Changelog for LFX Master DMX to firmware version > 2

Release date:
June 2018

Changelog of firmware update 2.0 for LFX Master DMX

NEW set-up procedure with firmware 2.0

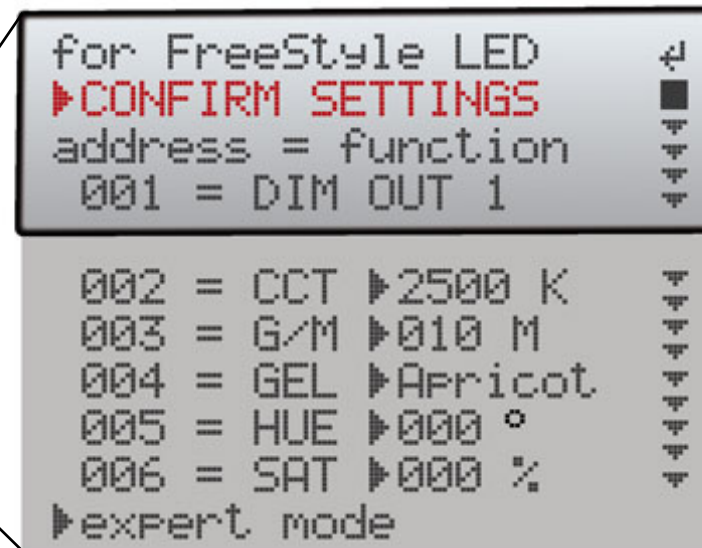
This firmware upgrade vastly improves lighting effect experience.

Enter the fixture settings instead of DMX values!

This significantly simplifies the set-up of LED fixtures.

- NEW: all DMX OUT device presets for ARRI and Kino Flo show now parameters in Kelvin, Green/Magenta, hue & saturation as instantly adjustable values instead of DMX numbers (see example on page 1)
